amq architectural & quantity surveying services			
address of works: Wood designs Workshop, Roundstone-by-pass, Angmering			
Drawing title: Proposed Amendments to Approved Plans			
Date:	Jan. 2018	Scales:	As shown
		Paper size:	A3
		Dwg No:	AR-133-B2

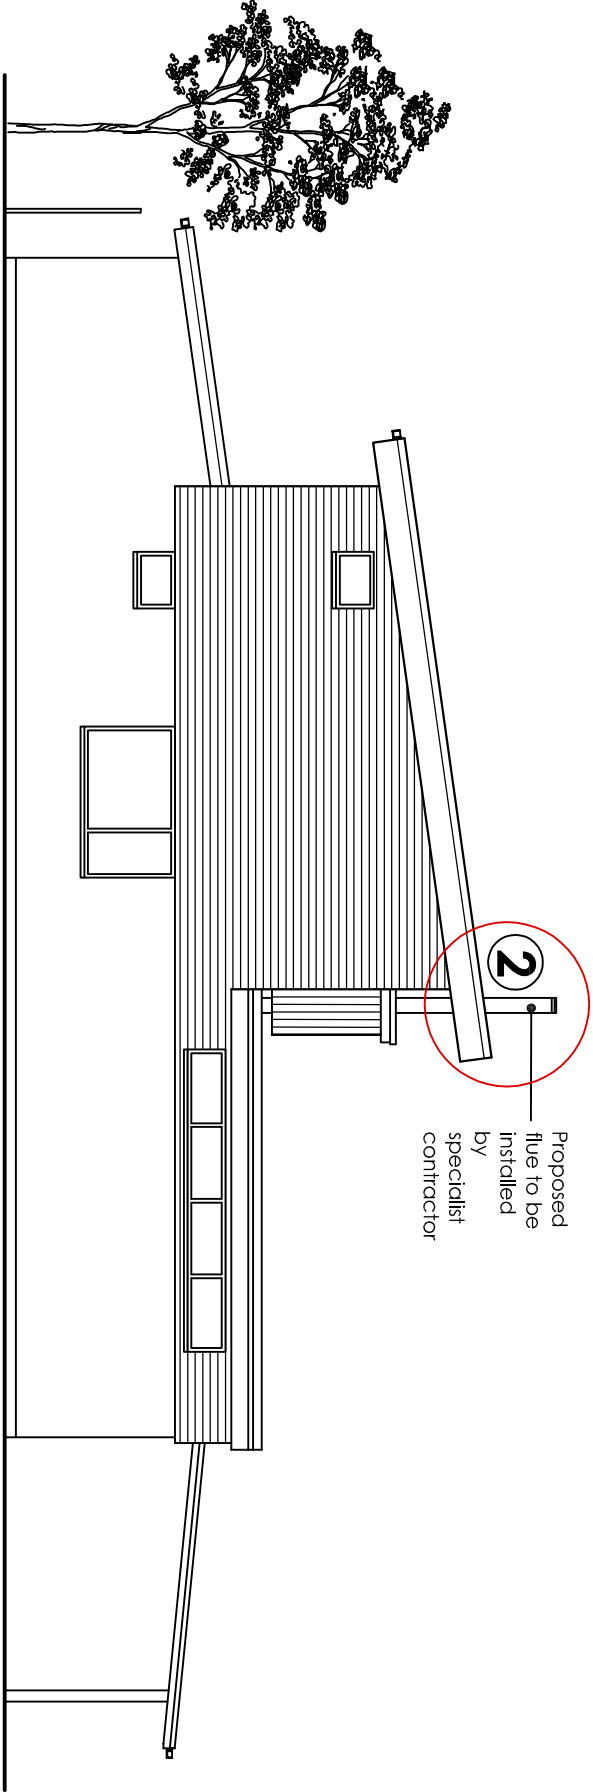
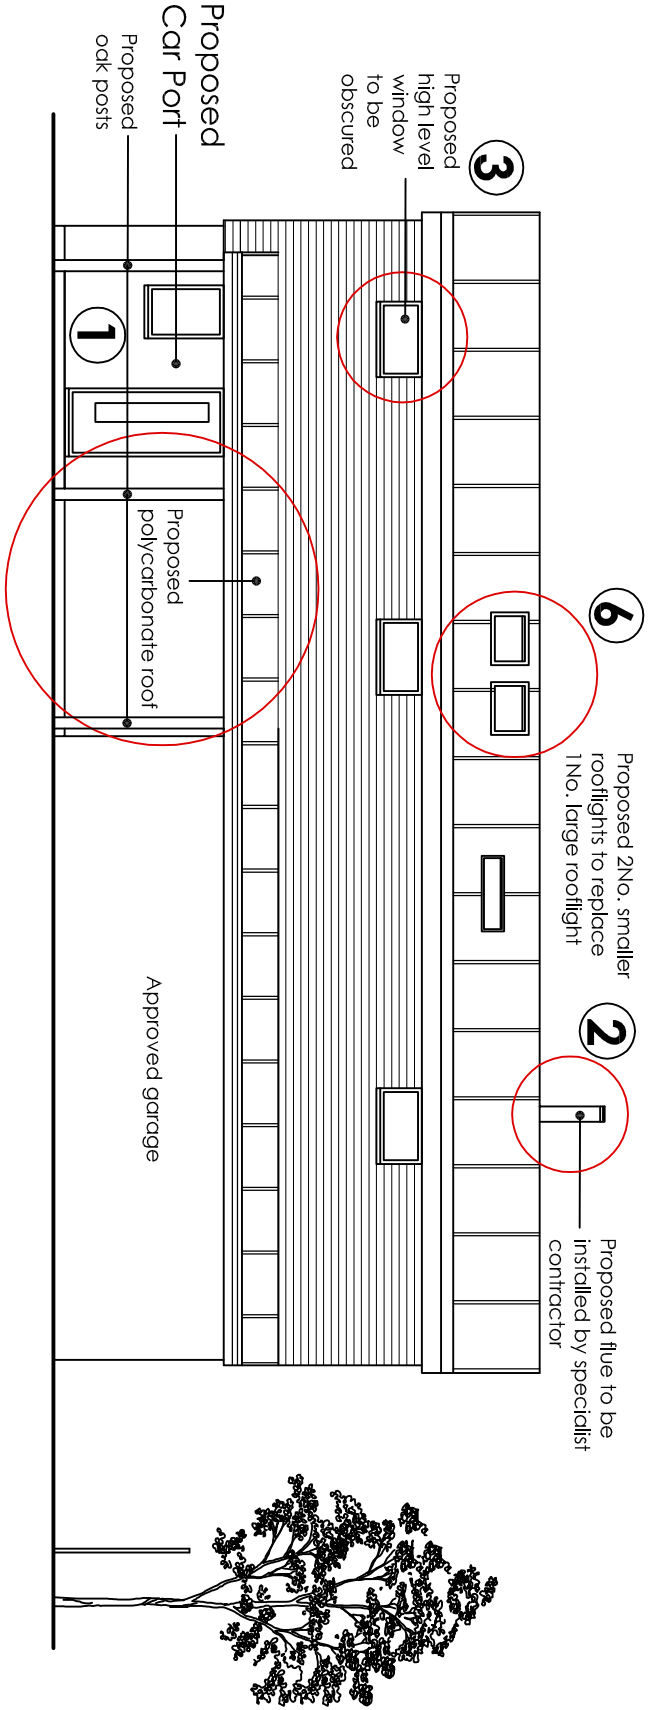
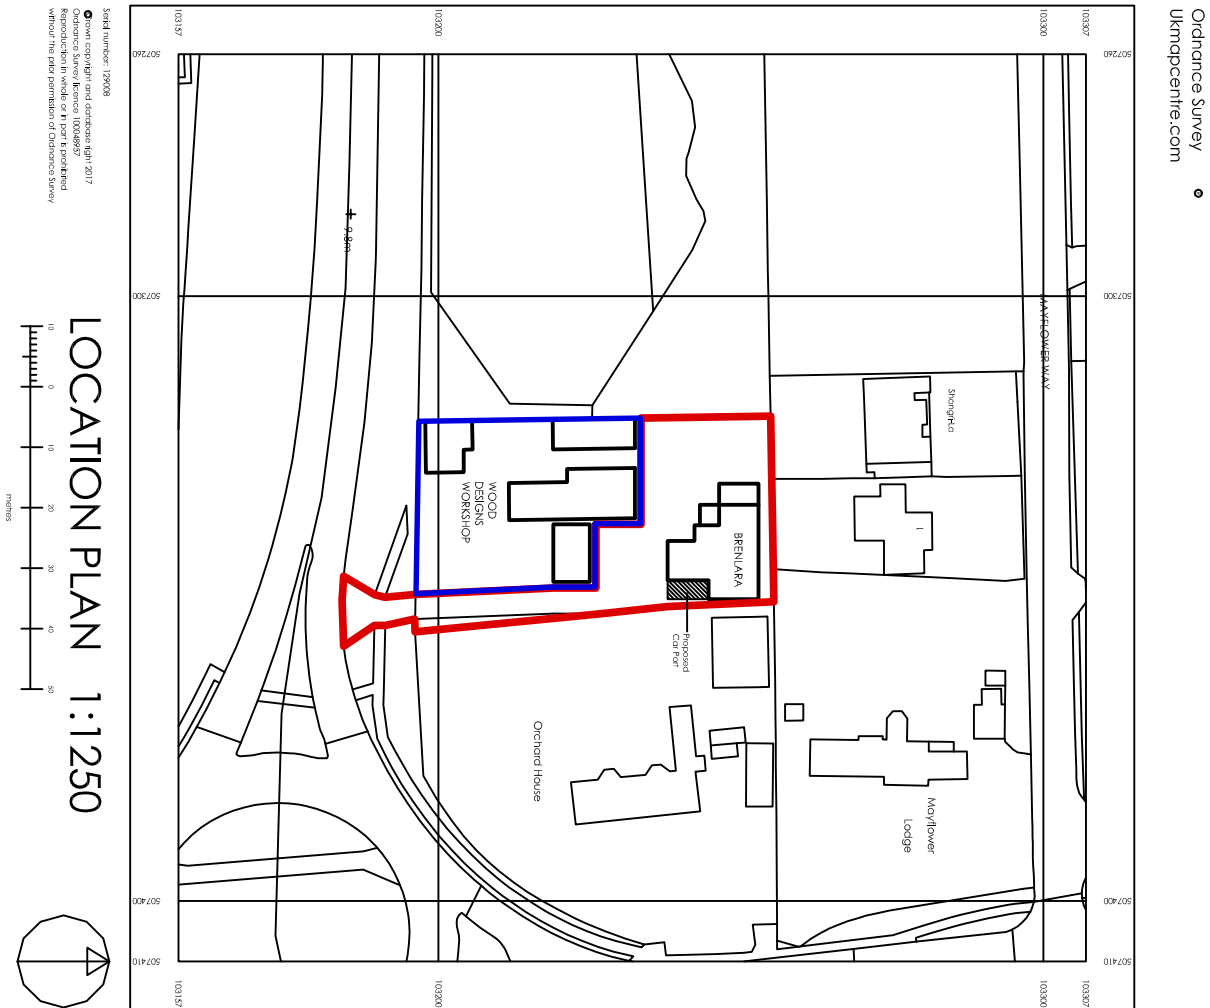
Proposals:

- 1) Car port
- 2) Flue on West elevation
- 3) High level window in new wardrobe on East elevation to have obscure glazing
- 4) First floor bedroom window on South elevation reduced in width
- 5) Proposed full length glazed door with glazed barrier to prevent falling
- 6) Proposed 2No. smaller rooflights to replace approved 1No. large rooflight
